ROTH BROS. SMELTING CORP. CORRECTIVE MEASURES STUDY REPORT ADDENDUM

File No. 70185-43 March 1994

Roth Bros. Smelting Corp. Corrective Measures

Study Report Addendum

Figure No.	<u>Title</u> .
1	Scenario #1-Soil Volume
2	Scenario #2-Soil Volume
3	Scenario #3-Soil Volume
4	TCLP Lead Remediation Areas

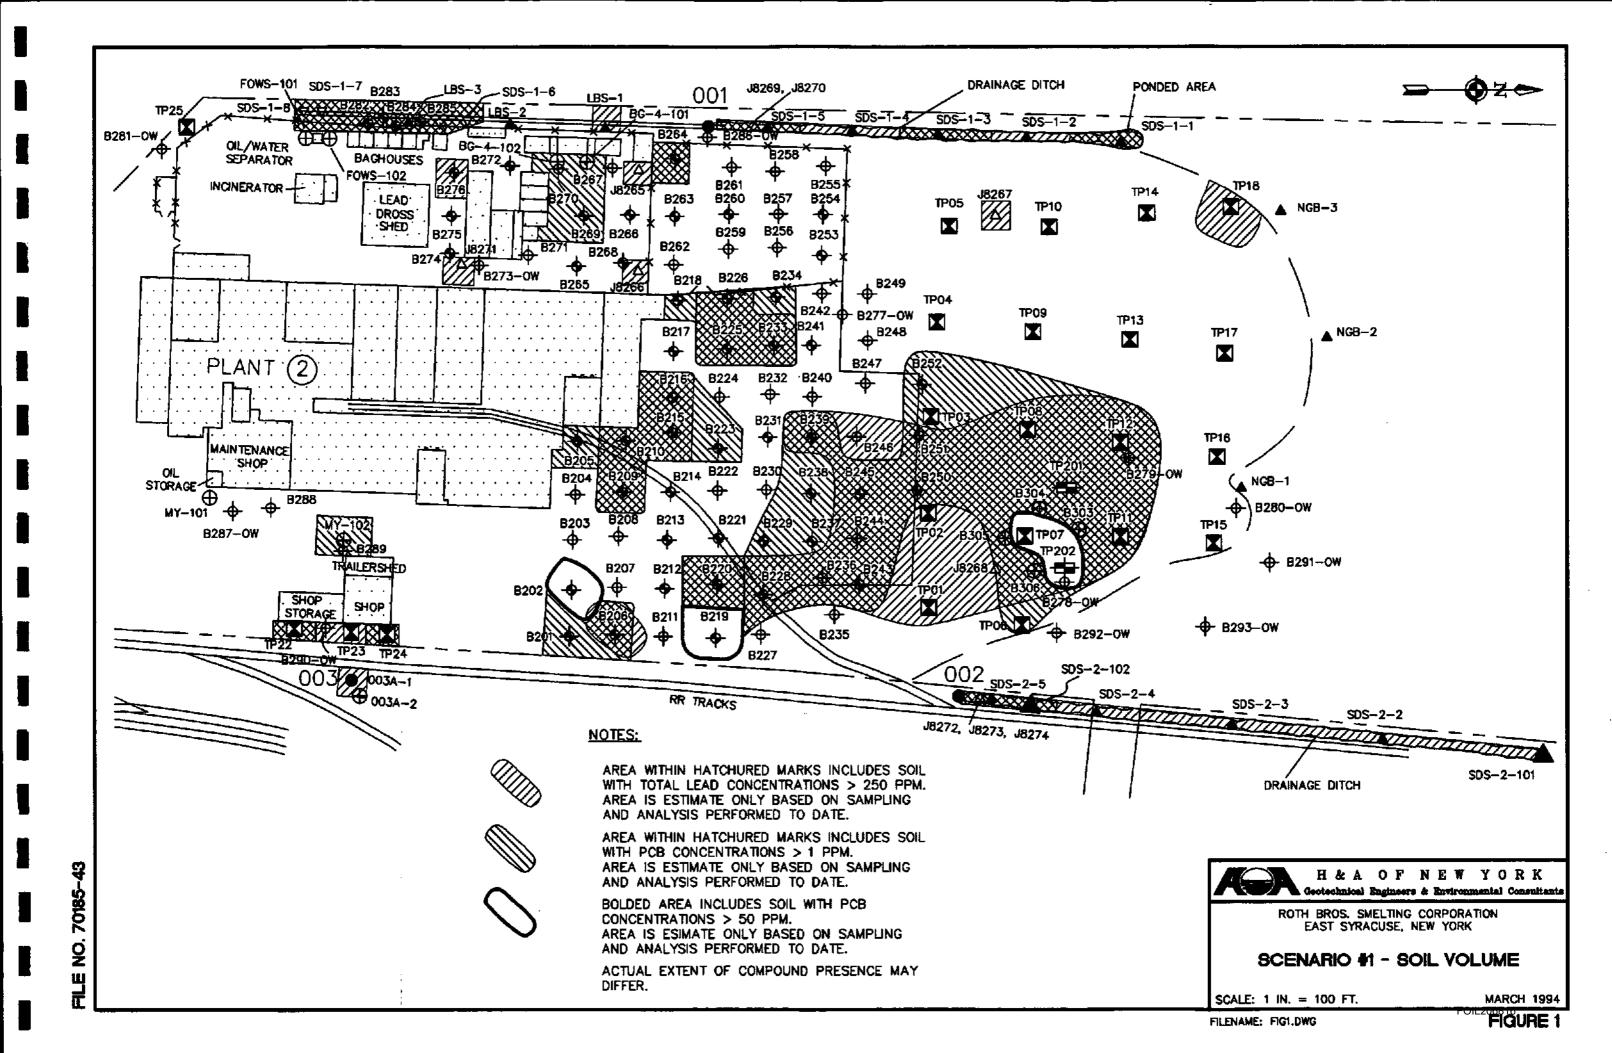
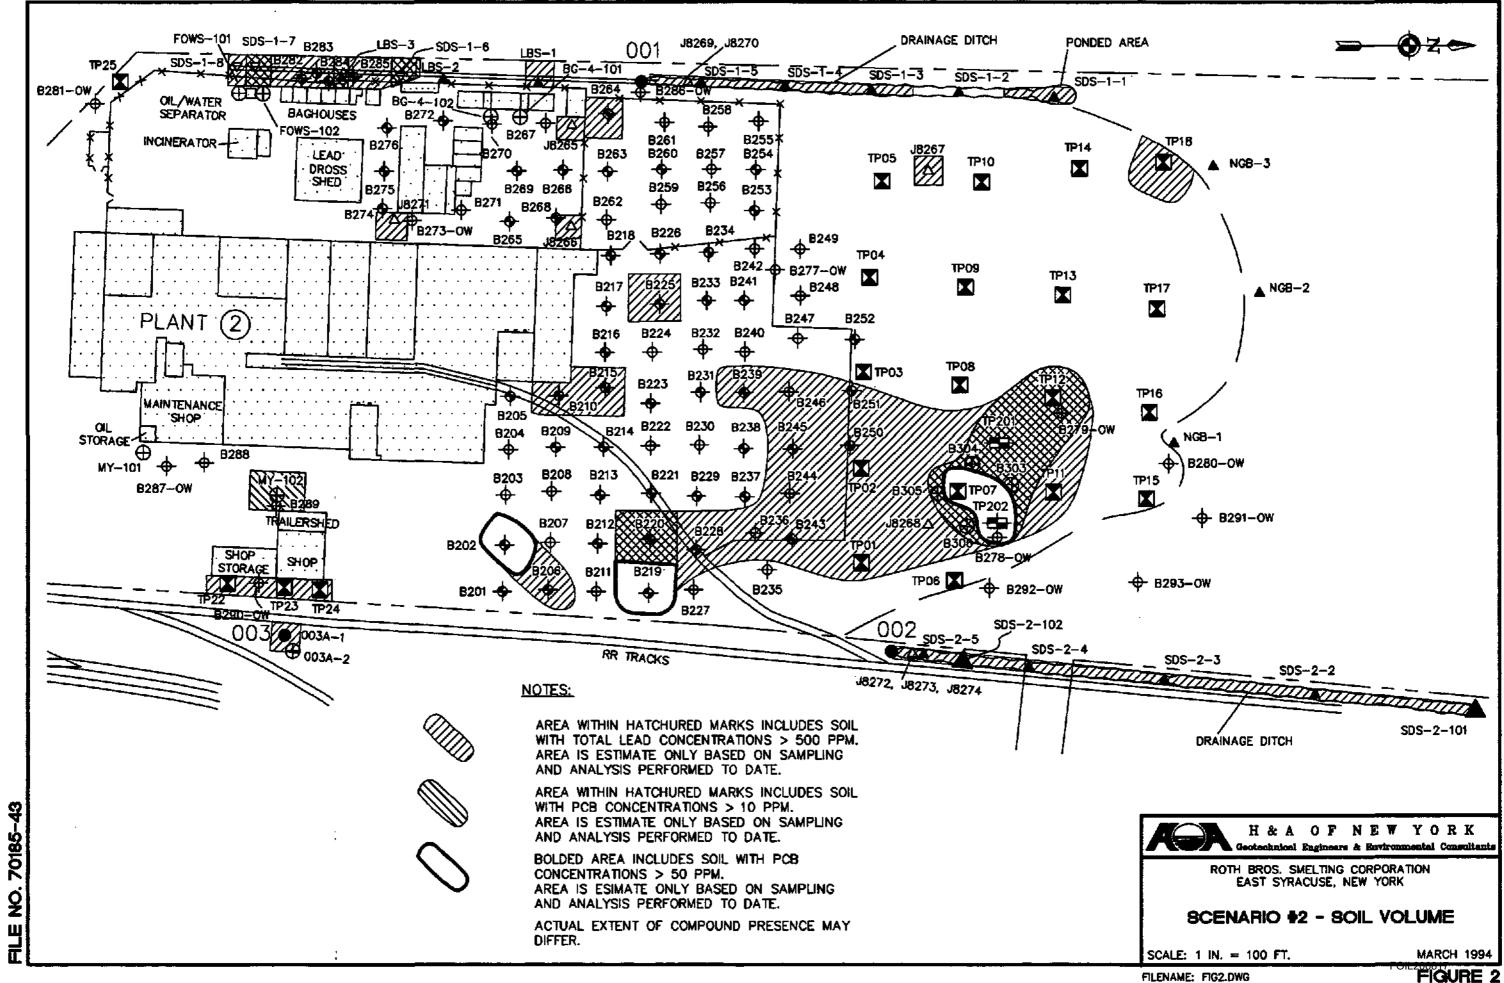
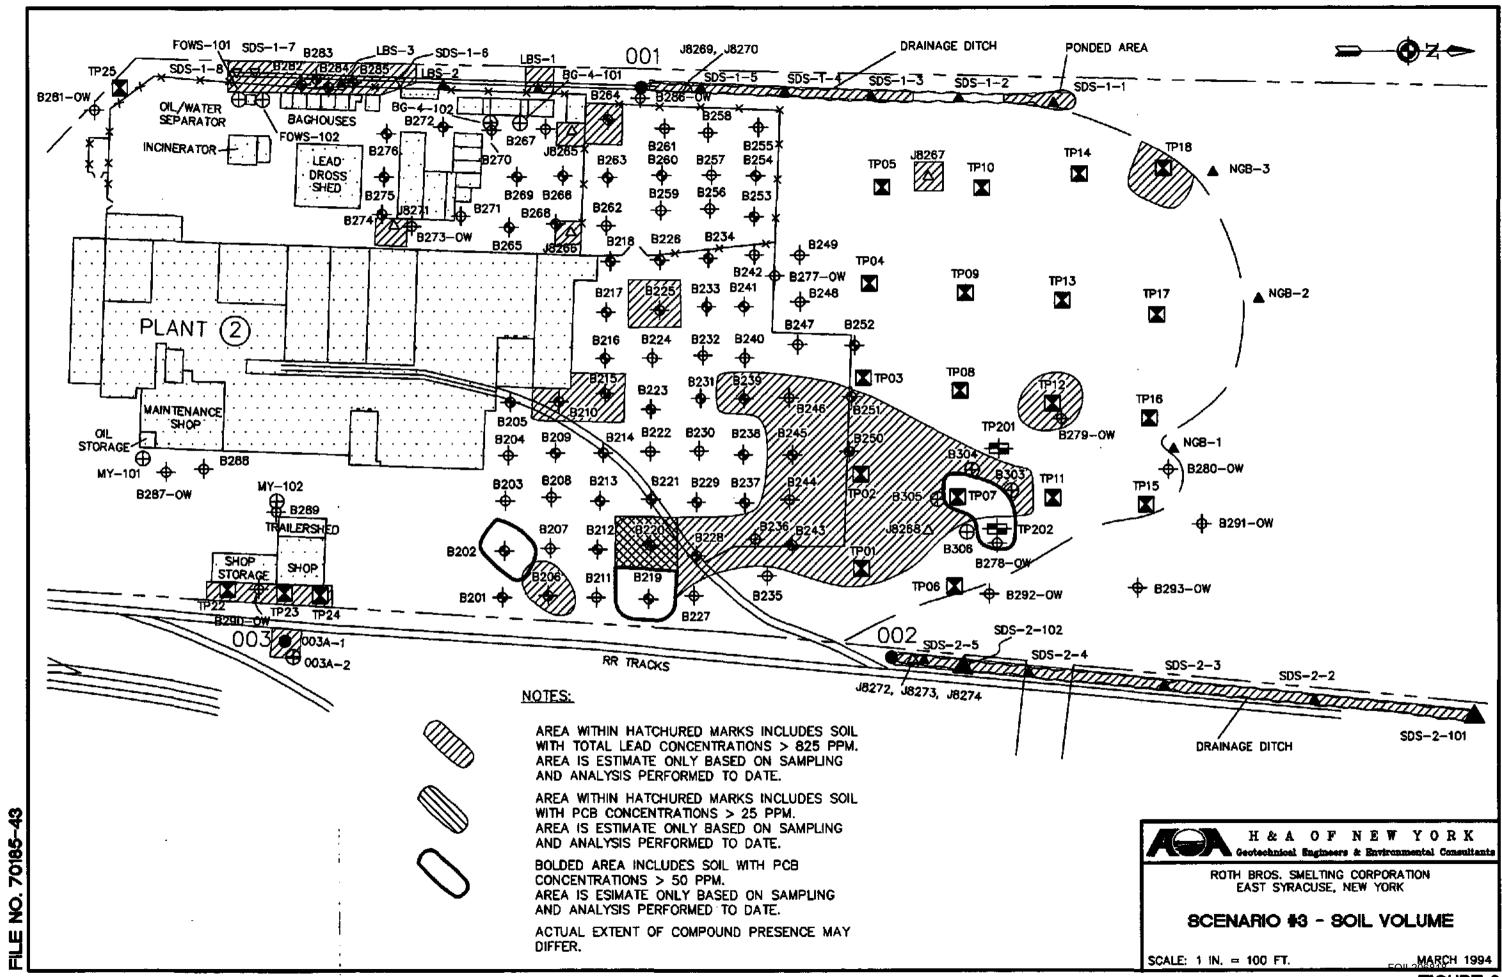
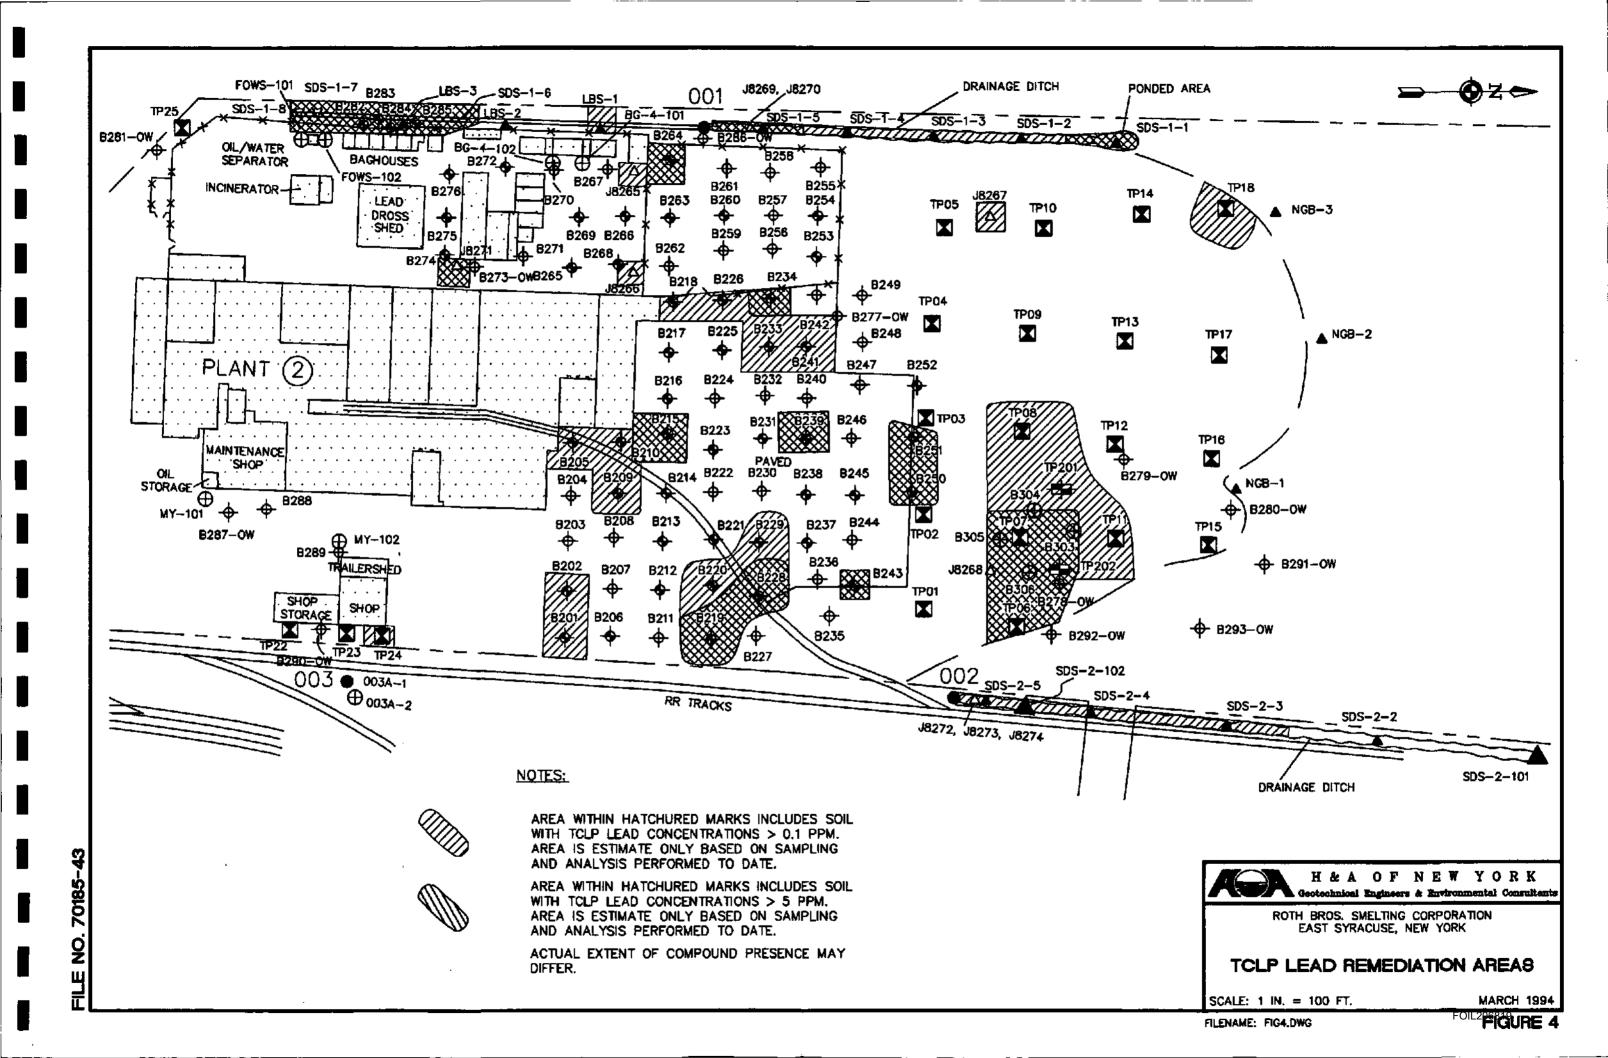
NYSDEC COMMENT: "DEC reserves comment on Section 3-04, until the New York State Department of Health (DOH) completes its review of the Risk Assessment calculations. To consider alternative corrective measures scenarios, you must perform three (3) soil volume calculations: 1) Pb at 250 ppm and PCBs at less than 1.0 ppm; 2) Pb at 500 ppm and PCBs at 10 ppm; and 3) Pb at 825 ppm and PCBs at 25 ppm. This will allow cost comparisons of different cleanup levels for each alternative. Please include the actual calculations used to arrive at the various soil volumes in the CMS addendum."

Using Figures 1 through 3 estimated soil volumes were calculated using each of the three sets of concentration criteria as listed above. Volumes were determined for both total lead and PCBs for each of the three scenarios. See Table I for a summary of these volumes. The actual calculations used to obtain the various soil volumes are located in Appendix A.

The preferred Corrective Measure scenario presented in the CMS of total lead >825 ppm and PCBs >25 ppm would apply to approximately 21.042 tons of soil (see Figure 3) with total treatment and disposal costs ranging from \$1.618,784 to \$1,788,784 (lead and PCB costs combined-see Table 1).

When comparing total volumes using cleanup criteria of total lead >500 ppm and PCBs at >10 ppm rather than lead at >825 and PCBs >25 ppm, there is an overall increase in total volumes of 3,680 tons or 18% (areas included are shown on Figure 2). This 18% increase in total volume translates into an estimated 13% increase in treatment costs alone, with total costs ranging from \$1,824,184 to \$1,994,864 (refer to Table I).

And finally, a 62% or 12,911 ton increase of total volume occurs when using lead at >250 ppm and PCBs at >1.0 ppm rather than lead at >825 ppm and PCBs at >25 ppm (affected areas are shown on Figure 1). This 62% increase in total volume translates into an approximate 45% increase in treatment costs alone, with total costs ranging from \$2,340,672 to \$2,511,352, (refer to Table I).
